Subject: Duke Energy Carolinas, LLC
William States Lee III Nuclear Station – Docket Nos. 52-018 and 52-019
AP1000 Combined License Application for the
William States Lee III Nuclear Station Units 1 and 2
Supplemental Response to Request for Additional Information
Ltr# WLG2012.06-10

Lee Nuclear Station Supplemental Response to Request for Additional Information (RAI)

Reference NRC RAI Number(s): 10.04.05-002

20) COLA Part 2, FSAR Figure 2.4.3-248 is added as follows:

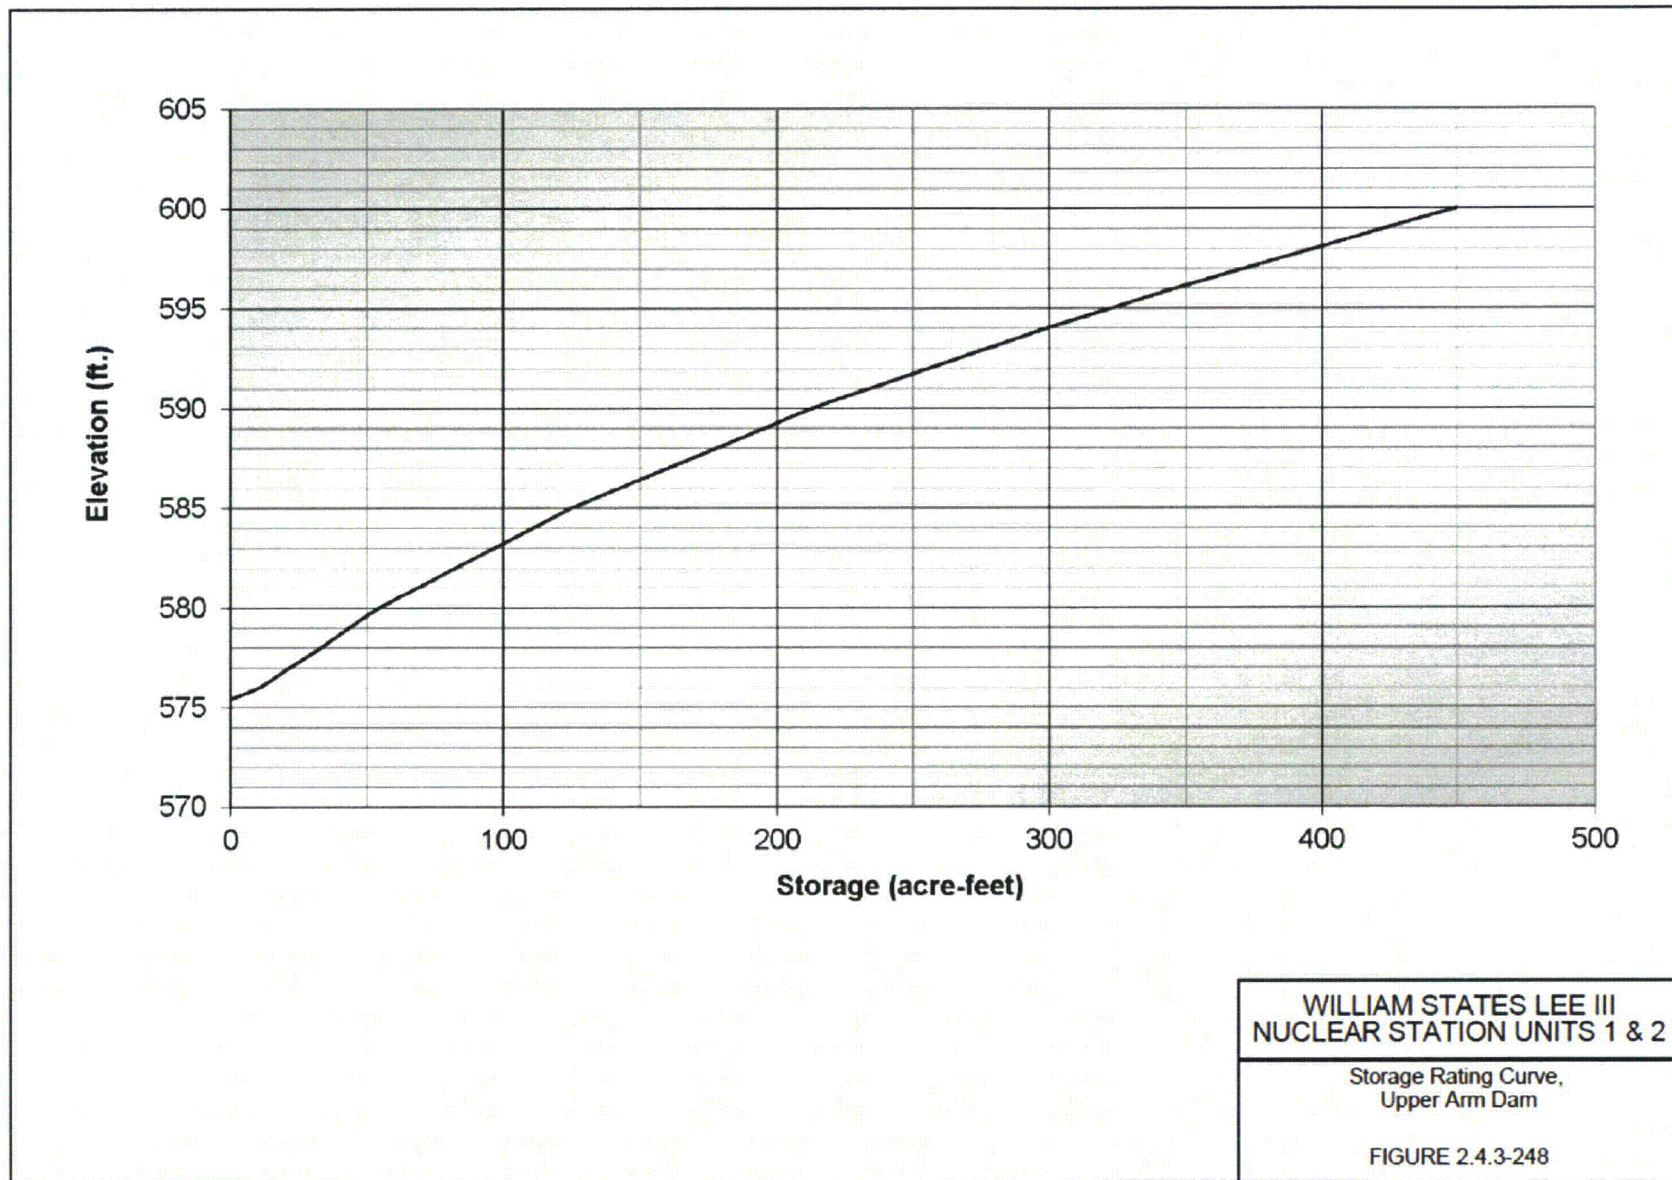
2.4.3-247 and is presented as a combination of culvert flow and weir flow. Available storage was determined based on aerial topography. Figure 2.4.3-248 provides the storage capacity curve. Antecedent conditions for the normal full pond elevation were assumed to be 575.4 ft. based on historical observation.

21) COLA Part 2, FSAR Figure 2.4.3-249 is added as follows:

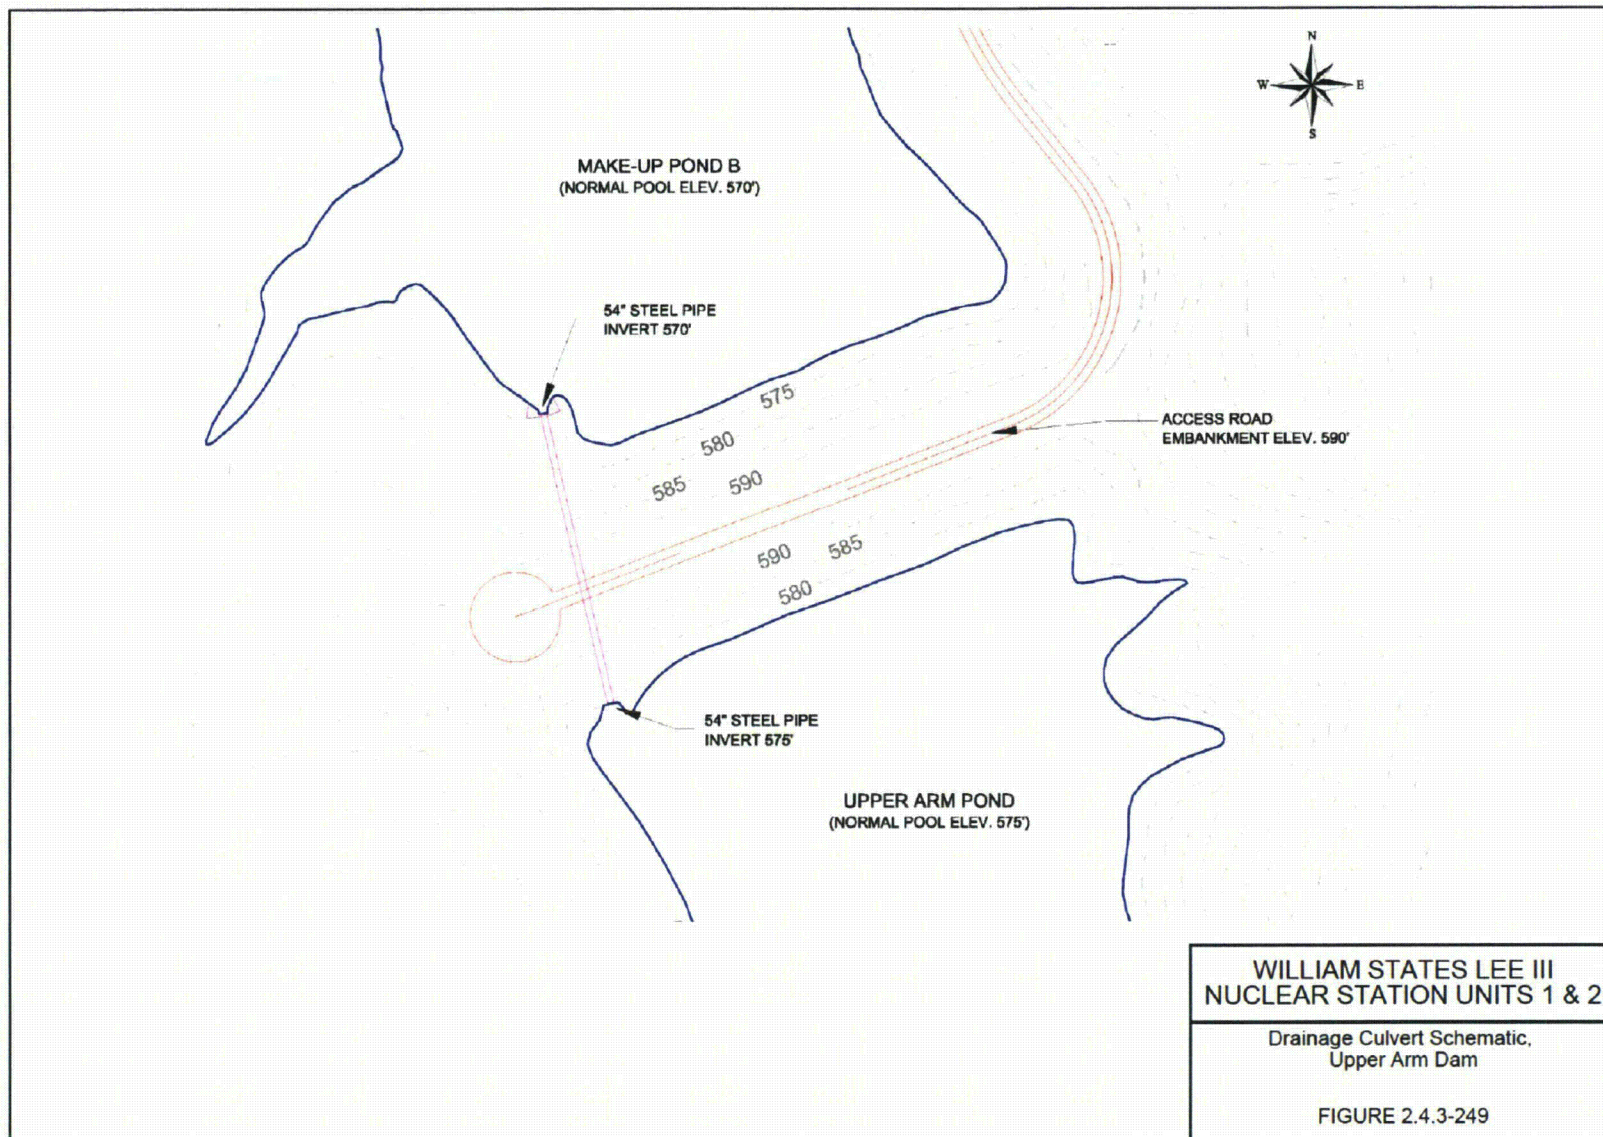
The Upper Arm Dam outlet structures consist of a 54 in. steel pipe with headwalls at both the upstream and downstream inverts. The upstream invert within the Upper Arm Dam is placed at an elevation of 575.0 ft., which is the normal full pond elevation. The downstream invert emptying into Make-Up Pond B is placed at an elevation of 570.0 ft. Figure 2.4.3-249 shows a schematic of the Upper Arm culvert structure.

- 4) COLA Part 2, FSAR Figure 2.4.5-201 is revised as shown:

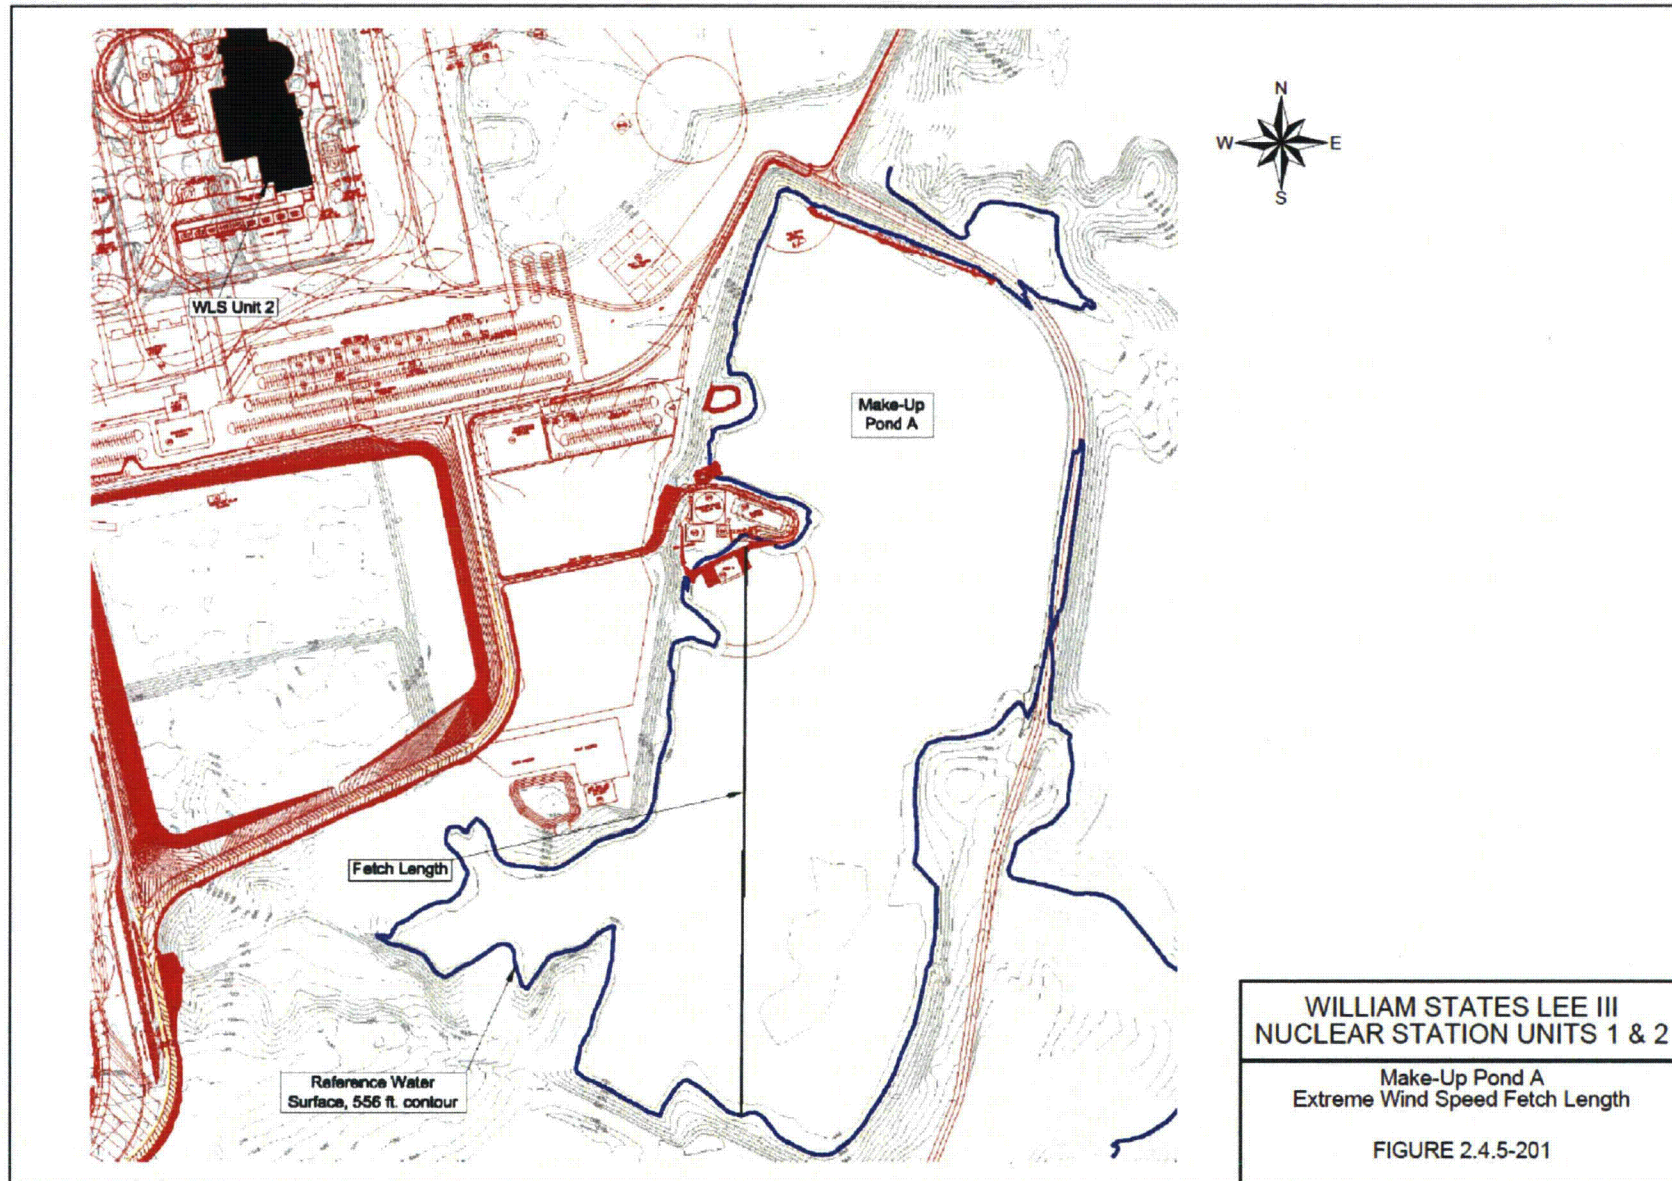
Make-Up Pond A surge flooding is evaluated coincident with the 100-yr. water surface elevation of 556.07 ft. The critical fetch length is 0.367 mi. as shown in Figure 2.4.5-201. The wind speed is adjusted based on the factors of fetch length, level overland or over water, critical duration, and stability using U.S. Army Corps of Engineers guidance (Reference 295). The critical duration is 10 min. The adjusted wind speed is 97.4 mph.
